Recommendation Meeting 2.0
Date 11/3/2016

PROJECT DESCRIPTION

RECOMMENDATION MEETING #1 GUIDANCE AND REPONSE

PLAN – 2ND FLOOR

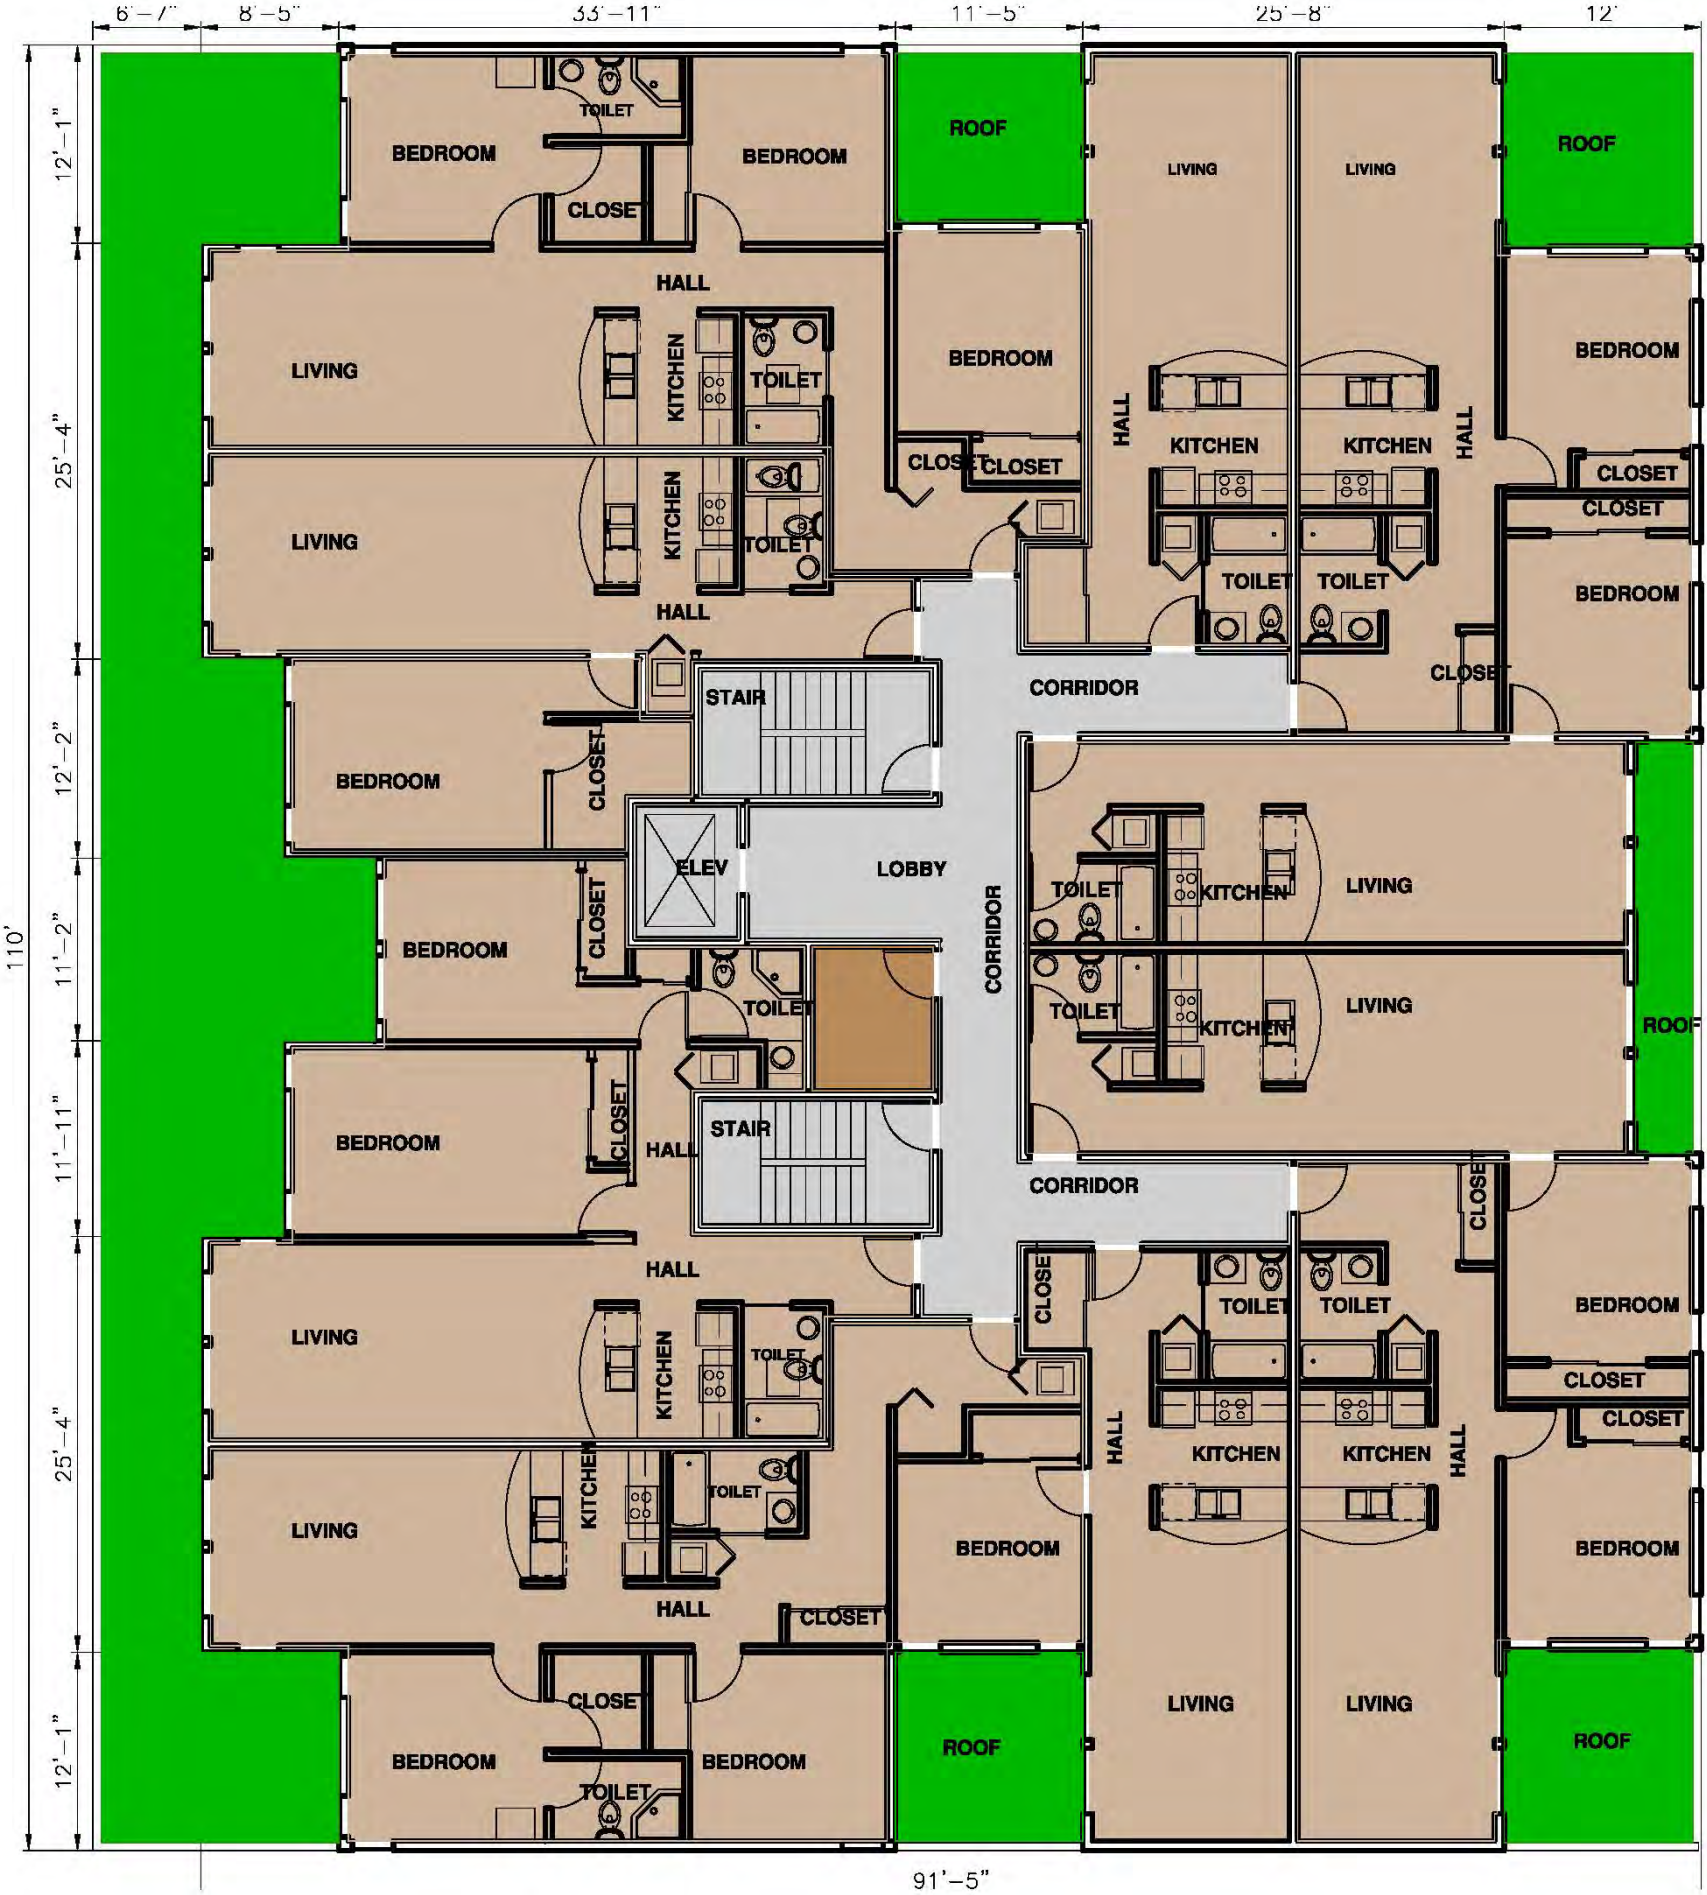
It appears from the drawings that the deck above the storefront would not be used by residents as a deck or for landscaping. This potential amenity would benefit the residents of the second floor units facing it. If the area is not to be actively used by the residents, the Board encourages the applicant to landscape the space. If landscaping is infeasible for some reason, then the floor of the deck should be painted a color other than white to be attractive to the residents at all levels who would be looking out or down at it. The Board asked that the amount of roof area devoted to landscaping and amenity deck be retained. Substitute another planting for the Vinca Minor in the landscape plan.

See revised plates 9 (second floor plan), 17 (landscape plan), 18 (plant list), 21 (rendering)

LIGHTING PLAN

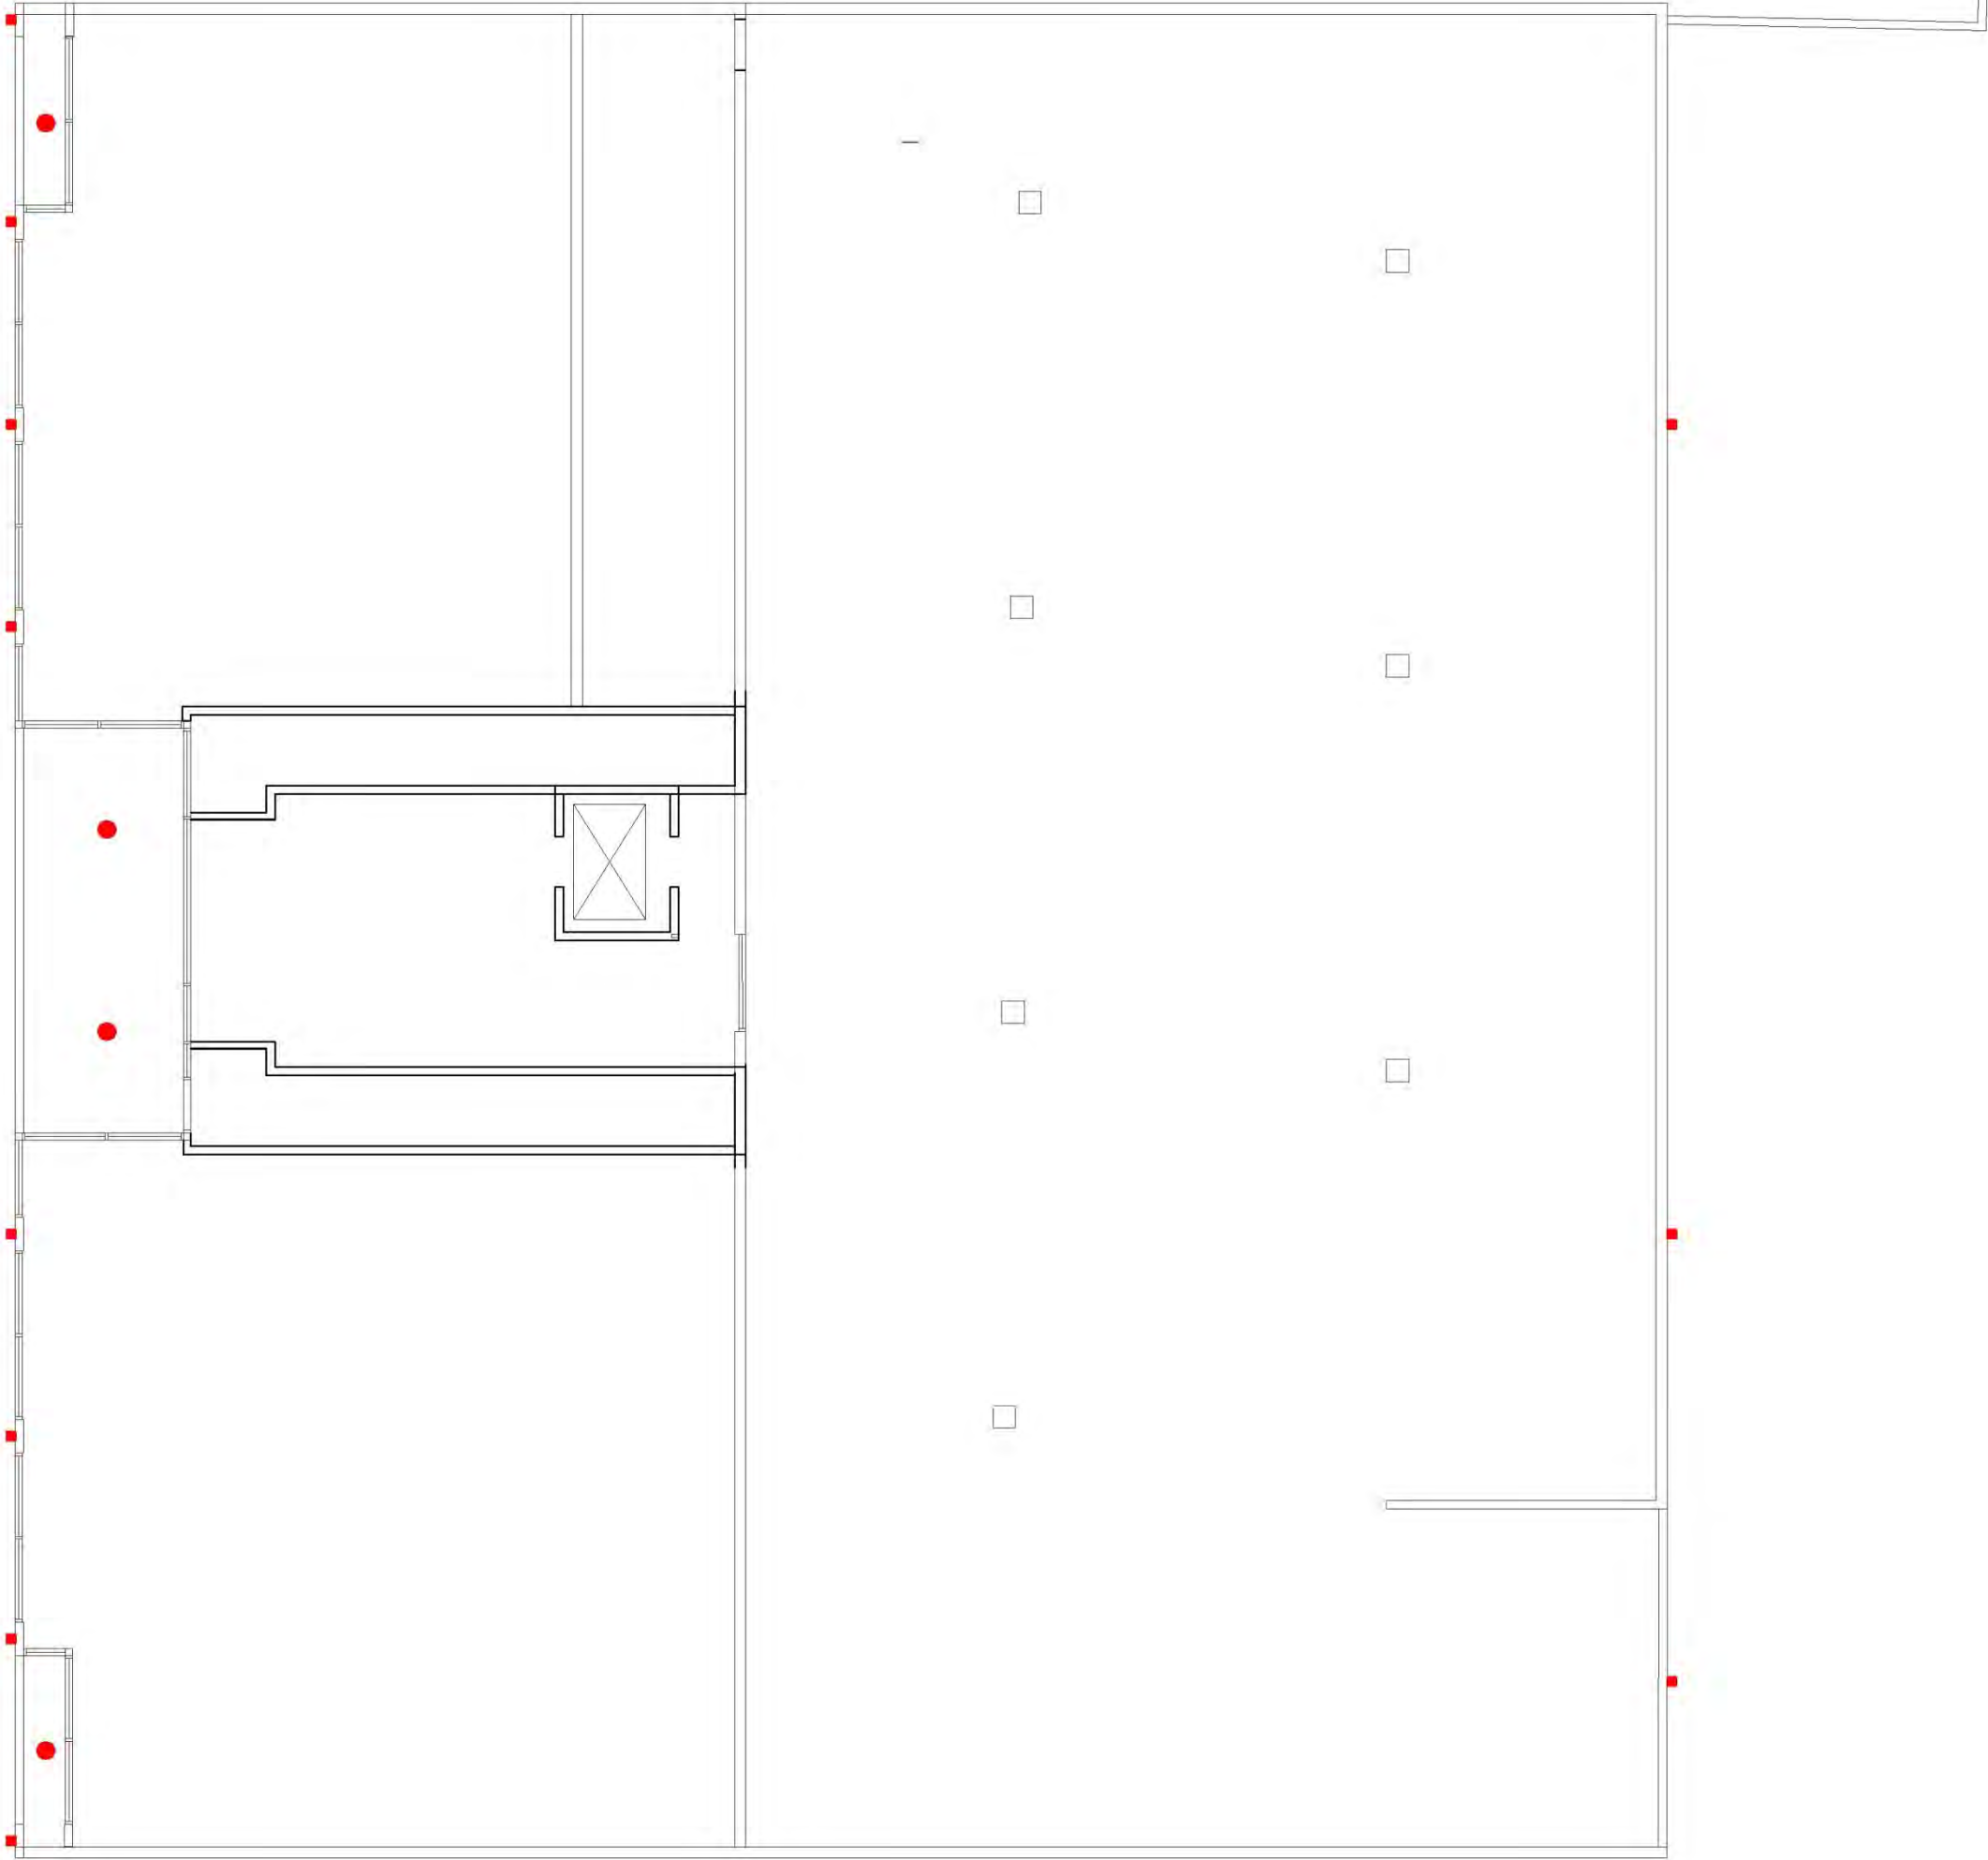
Provide a lighting plan at the next Recommendation meeting

See revised plate 12 (lighting plan)
